# Access Compliance Report

## Public Rights-of-Way

### (Curb Ramps)

Intersection ID: 12316	Main Street: ASHLEY_RD	Cross Street: GREENLAND_AV	Location: SW
ADA ID: D6AE37FE0754	Ramp Type: Perp	Initial Pass/Fail: Pass	Overall Compliance: No
Severity Score: 2.75			
Codes/Mitigation Info/Possible Solution		Field Measurements/Component Compliance

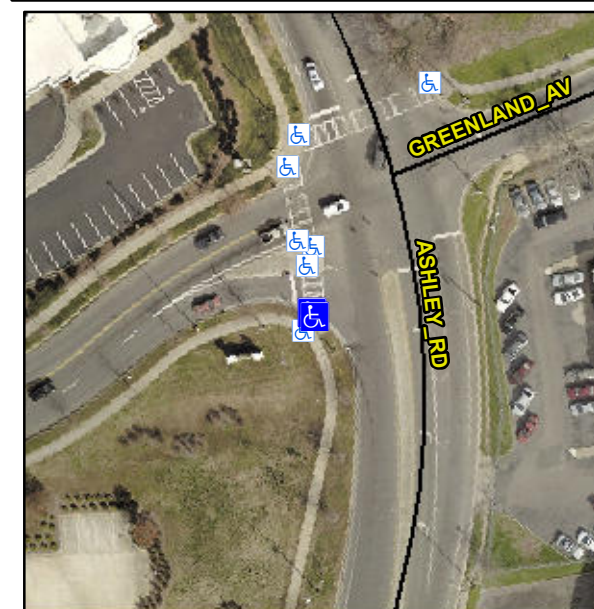
**Not Found, R304.2.2-Perp, R304.3.2-Para, R305.1.4**

Compliance	Description	Data	Compliance	Description	Data
N/A	Ramp Length (in)	62.5	Yes	Ramp Slope (%)	5.9
Yes	Ramp Width (in)	58.0	Yes	Ramp XSlope (%)	3.4
N/A	Flare Type LT	Sloped	N/A	Flare Type RT	N/A
N/A	Flare Slope LT (%)	0.2	Yes	Flare Slope RT (%)	7.5
N/A	Flare Traversable LT?	Yes	N/A	Flare Traversable RT?	Yes
Yes	Landing Length (in)	70.0	Yes	DWS Provided?	Yes
Yes	Landing Width (in)	60.0	Yes	DWS Contrast?	Yes
No	Landing Slope (%)	2.8	Yes	DWS Length (in)	24.0
Yes	Landing X Slope (%)	3.7	No	DWS Full Width?	No
N/A	Landing Curb? (Y/N)	No	Yes	DWS Offset (in)	1.0
N/A	Shared Landing?	No			
Yes	Gutter Ponding?	No	Yes	Gutter Slope (%)	4.5
Yes	Gutter Lip Ht (in)	0.0	Yes	Gutter X Slope (%)	3.4
N/A	Painted X Walk1?	Yes	N/A	Painted X Walk2?	N/A
	X Walk 1 Direction	To N		X Walk 2 Direction	N/A
N/A	X Walk 1 Width (in)	116.0	N/A	X Walk 2 Width (in)	N/A
	X Walk 1 Slope (%)	0.4		X Walk 2 Slope (%)	N/A
	X Walk 1 X Slope (%)	4.2		X Walk 2 X Slope (%)	N/A

**Remove & Replace Entire Ramp.**
